Summary of initial SSD review deliberations

SSD group – February 1, 2008

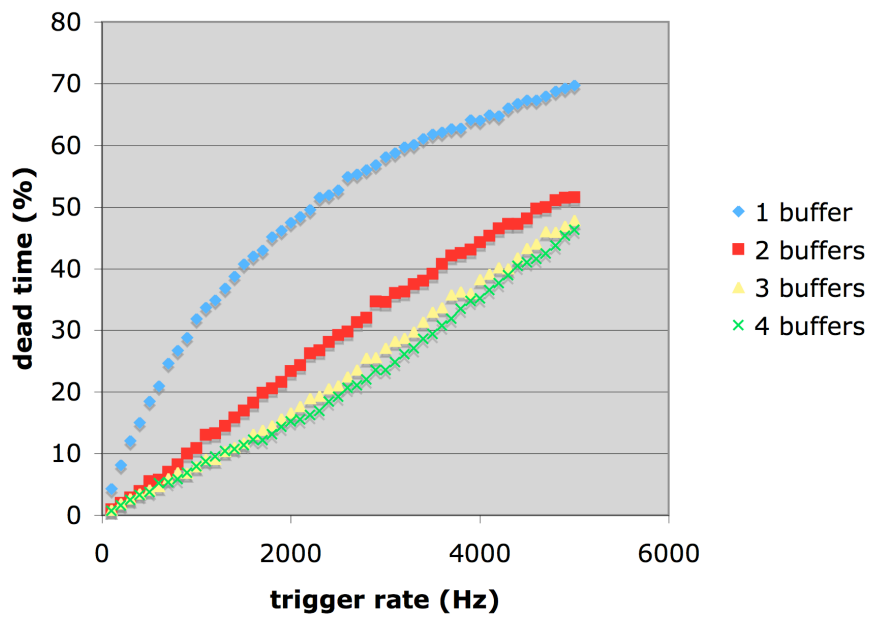
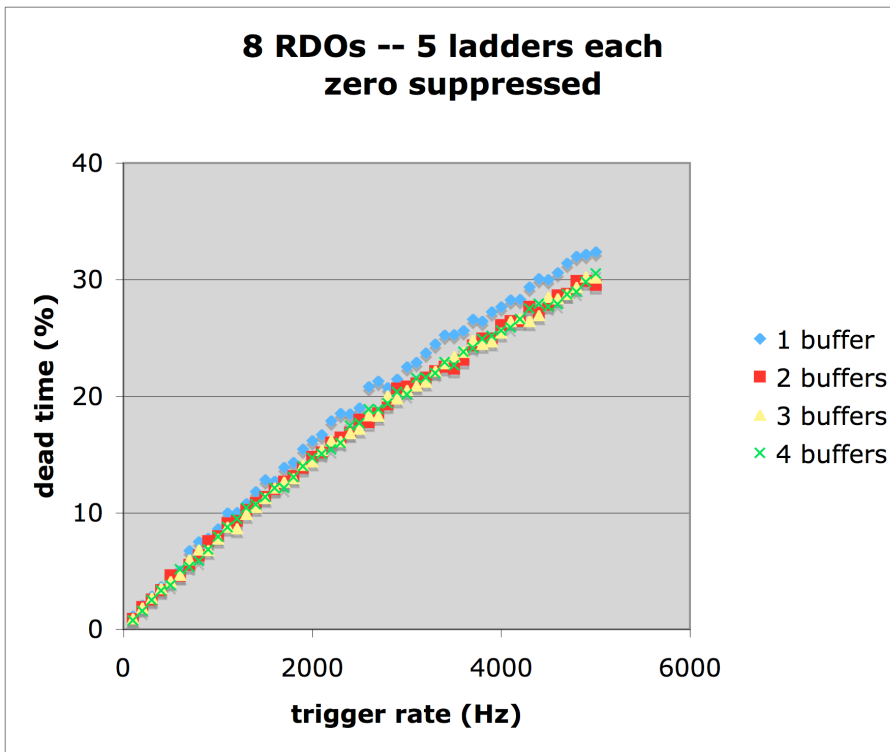
7.) We propose to set the level of 'acceptable dead time' to less than 10% at 1 kHz trigger rate, because we should assume that all systems in DAQ1000 should be laid out for a 1 kHz trigger rate (even if this might not be fully achievable for the TPC). Figs.12/13 show that this acceptable dead time can be accomplished with the proposed readout chain. In order to evaluate the simulation, though, we would like to see at which trigger rate the linear increase in dead time breaks down.

The calculations have been carried out for trigger rates up to 5000 Hz.

The non-linear behavior of the (non zero suppressed) system becomes evident.

It is clear for the non-zero-suppressed system that the multi-buffered system's behavior approached that of the single buffer at a trigger rate of about 6000 Hz.

For the zero-suppressed system, the DDL transfer time is assumed to be 10 us (3% occupancy); the characteristic dead time corresponds to the FEE data transfer to the RDO (85 us), so the limiting behavior will be above 10 kHz.
